# SUPPLIER NONCONFORMANCE REPORT

Item Drawing/Part# SE185-311 Part 02

Job Description: NCSX FPA Station 3 Fixture

02 ASSEMBLY - REAR LASER PEN MOUNTING BRACKET WELDMENT  
SCALE: 1:1000

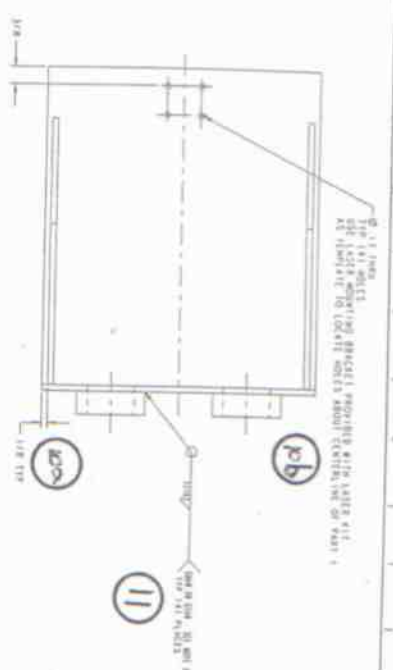
Drawing calls for ASTM A36 material. Vulcan ordered A36 material with certification. The certification provided does not identify any standard other than "commercial quality" and lists no mechanical properties. The listed chemistry conforms to A36.

ITEM	REQUIREMENT/INSPECTION RESULTS		CLASS	DISPOSITION/INSTRUCTIONS		DISP. APPROVAL DATE		
1.	<i>Required material per drawing is 1/8 THK ASTM A36.</i>			<i>VPC is submitting this report as a nonconformance.</i>		<i>Inspection</i> <i>Def MRB sibbs</i>		
	<i>Material certifications on hand do not show that material is certified to A36.</i>			<i>would like to manufacture and ship with "as is" material.</i>		QUALITY ENGR		
	<i>1 1/2" x 6 FB.</i>					DESIGN ENGR		
						PROCUREMENT		
						PLANNING		
						REWORK COMP BY		
						MFG. INSP		
						RESPONSIBLE ORG.

1. *RD was written correct in ordering A36 material*
2. *Corrective Action to Supplier to:*
  - a) *Send material that is ordered on VPC RD.*
  - b) *Provide material sets in a timely fashion.*
